WATER PERMIT NO. 2689-2

Application For Permit To Appropriate Water Within The State Of South Dakota

We have reviewed the plans and specifications for your dam project located in the NW ¼ SE ¼ of Sec. 28-T102N-R75W, in Tripp County. The plans and specifications for the reconstruction of the existing dam are approved. Approval of the plans and specifications does not authorize reconstruction of the dam. The reconstruction of the dam may not begin until Water Permit No. 2689-2 is approved.

REPORT ON
WATER PERMIT APPLICATION No. 2689-2
Julie E. Snavelly
August 29, 2012

#1 W 1/2 SE 1/4 Sec 28-102-75

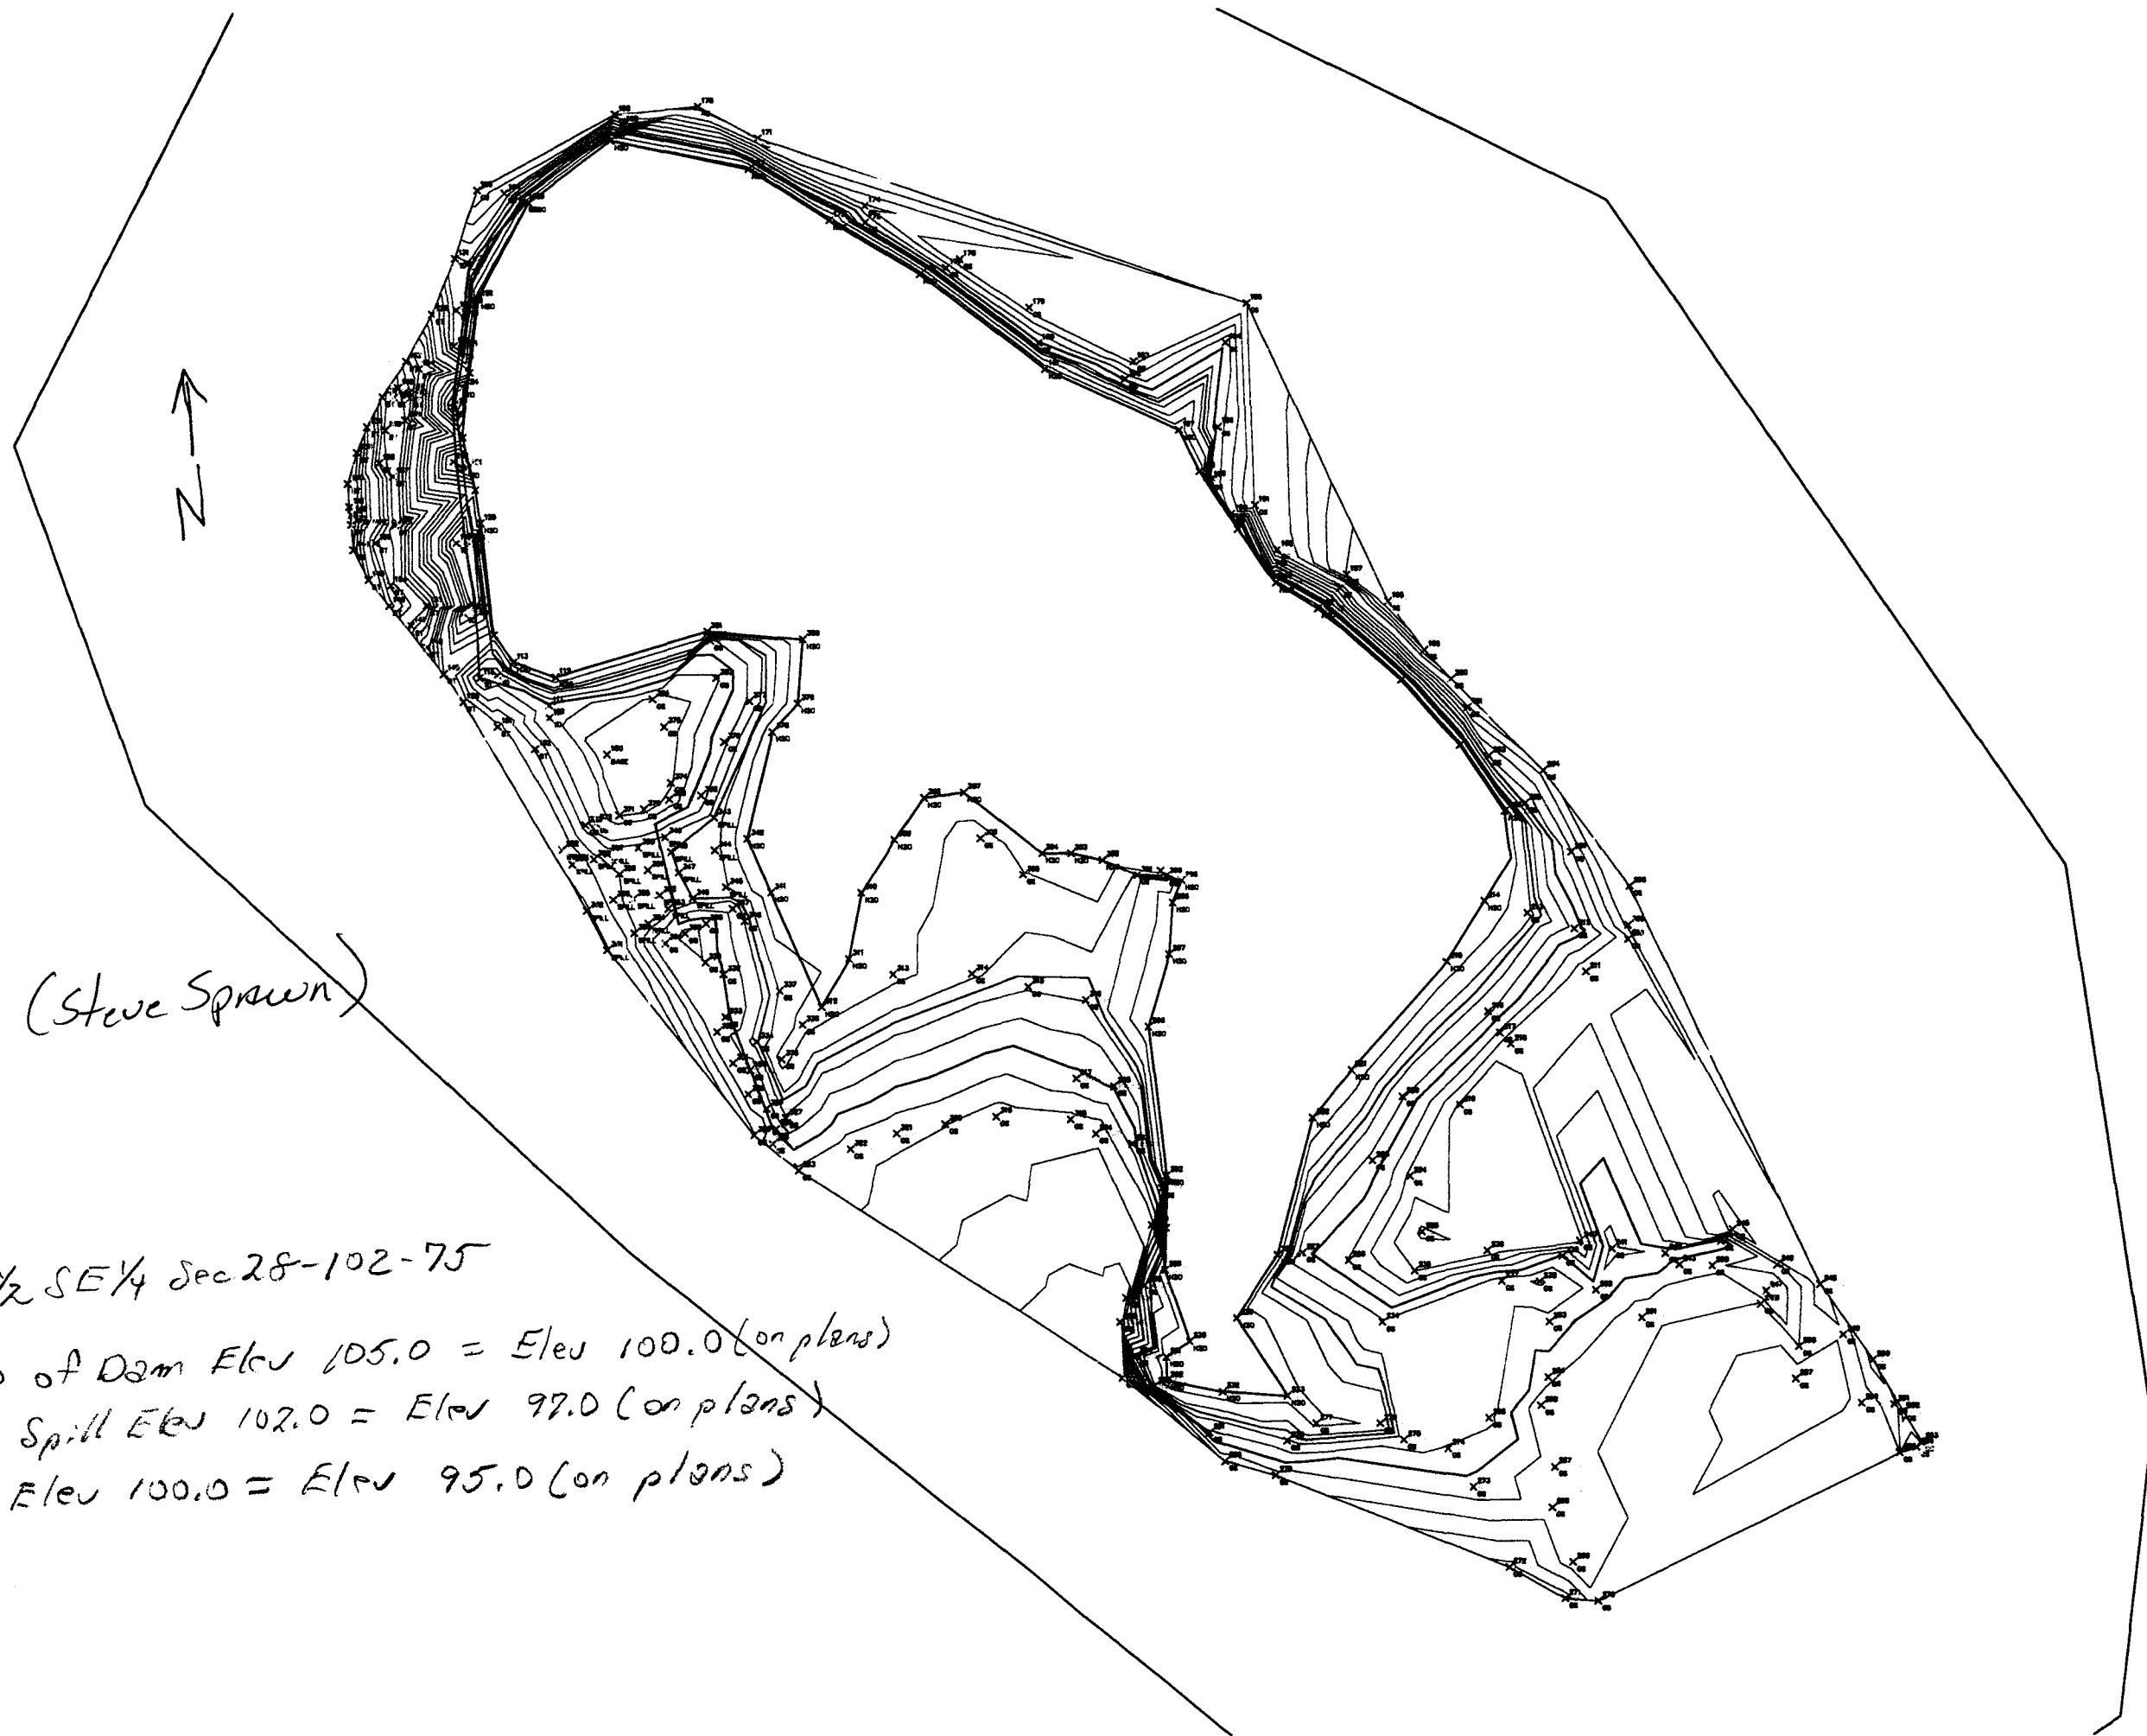
Note: Top of Dam Elev 105.0 = Elev 100.0 (on plans)

Em. Spill Elev 102.0 = Elev 97.0 (on plans)

P.S. Elev 100.0 = Elev 95.0 (on plans)

CROSS SECTION OF DAM ALONG E OF PRINCIPAL SPILLWAY

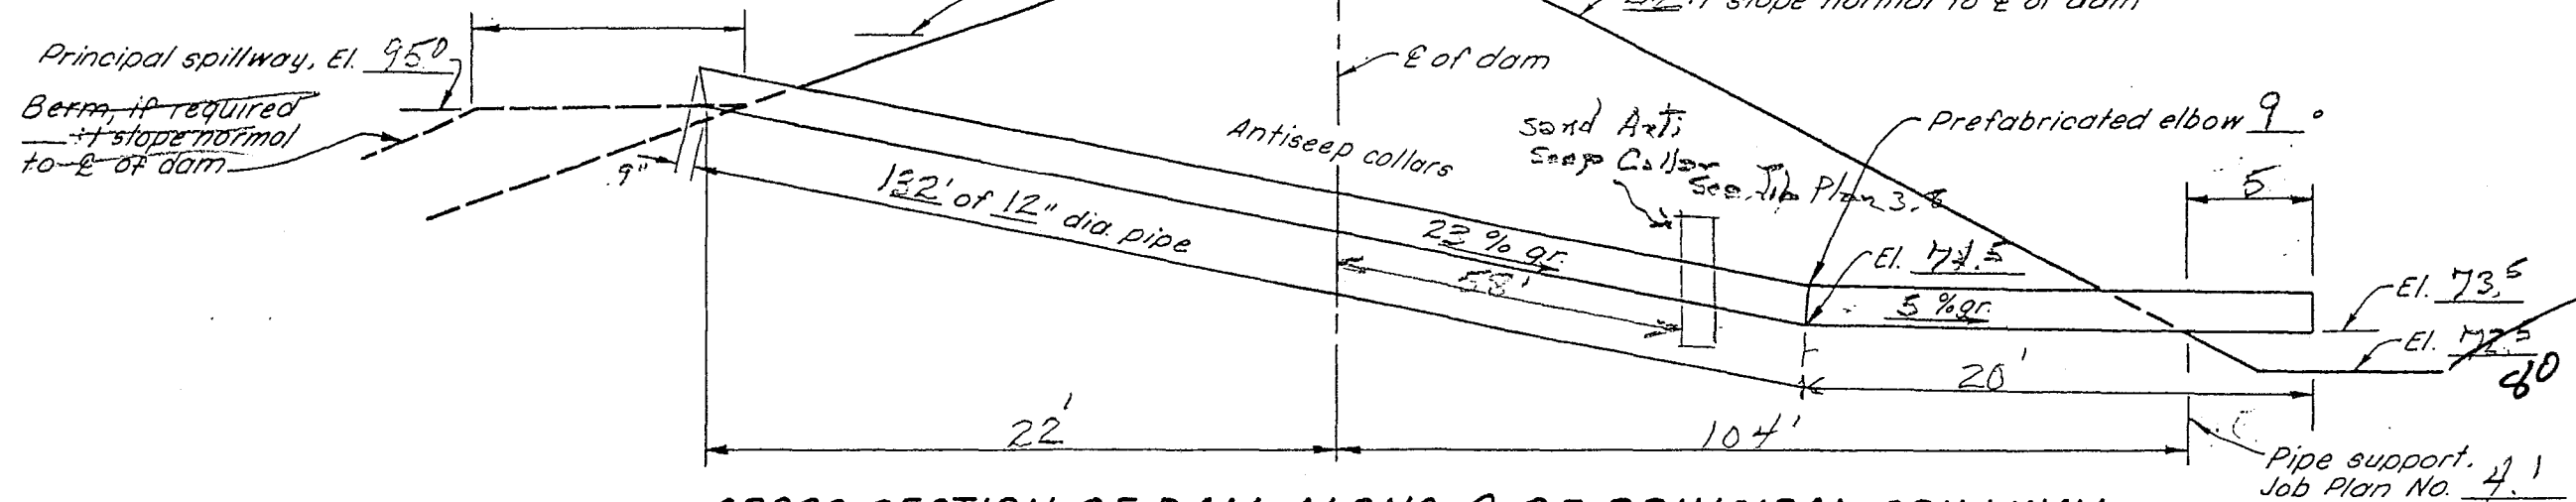
SDR # 26

- Paint all exposed PVC Pipe with a Water Base Paint
